COMMISSION FOR
HISTORICAL & ARCHITECTURAL
PRESERVATION

DRAFT STAFF REPORT

REQUEST: Construct two-story rear addition with roof deck

ADDRESS: 444 Grindall Street (Federal Hill Historic District)

Image 13: 444 Grindall Street – Proposed rear elevation

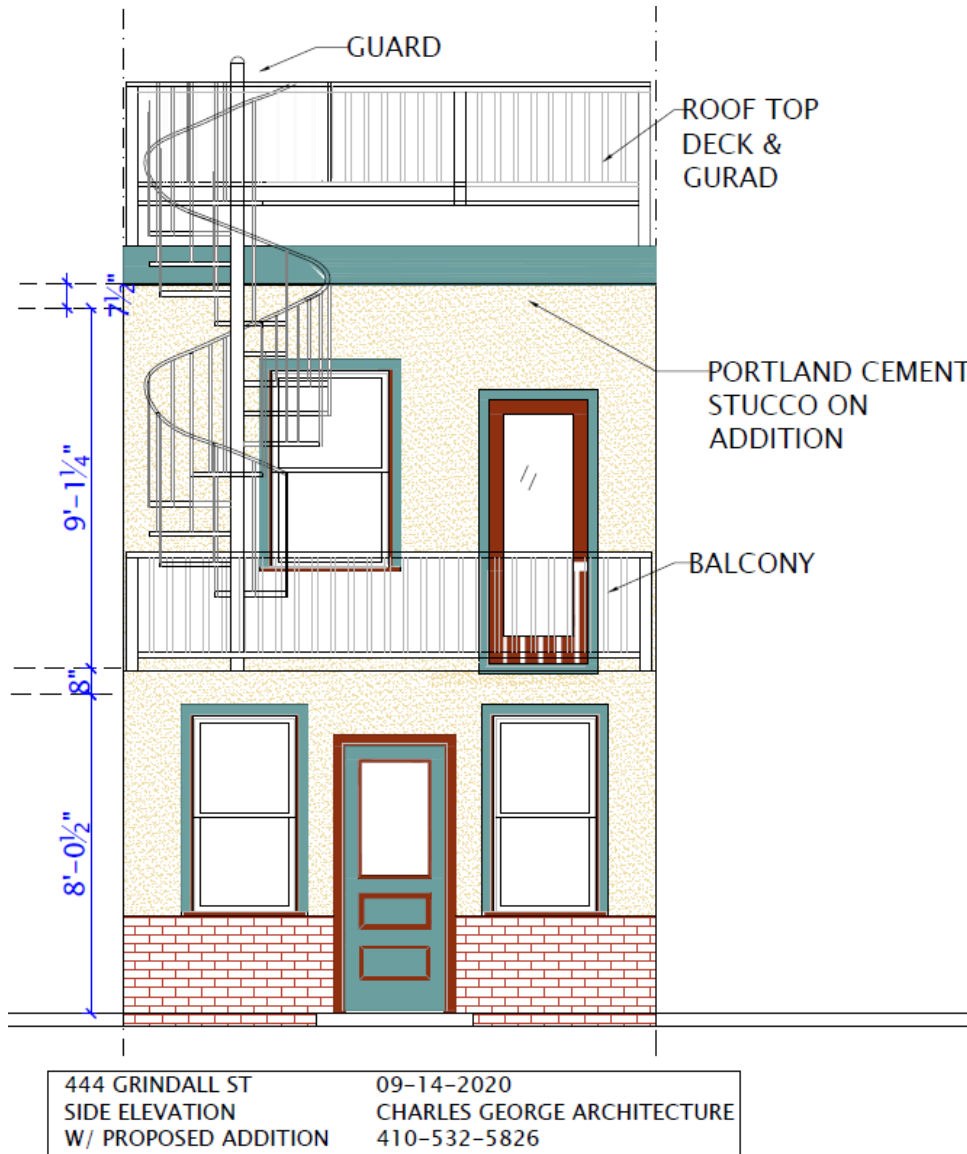
2.5.1 Doors and Windows – The doors and windows of the rear addition meet the design guidelines. The doors will be wood with glass half-lights. The windows will be Andersen windows made of Fibrex, a composite material. As these windows are proposed for the rear elevation, the doors and windows meet the design guidelines.

2.5.2 Materials – The CMU masonry of the east and west elevations of the existing one-story addition will be retained. The new construction of the addition at the expanded first floor and new second floor will be clad in Portland cement stucco. The materials meet the guidelines.

Image 17: 444 Grindall Street – Roof plan

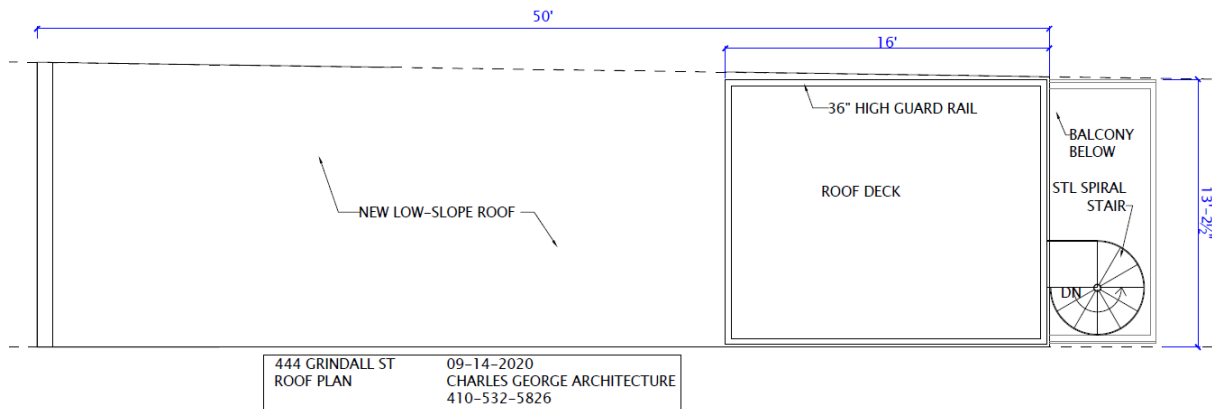
1.8.9 Roof Decks – The roof deck will be set back 34' from the front edge of the house. It will have a simple wood railing. Access will be provided by exterior spiral stairs coming up from the new balcony at the second floor. No access structure or doghouse will be on the roof itself. It will not be visible from the street. The roof deck meets the design guidelines.
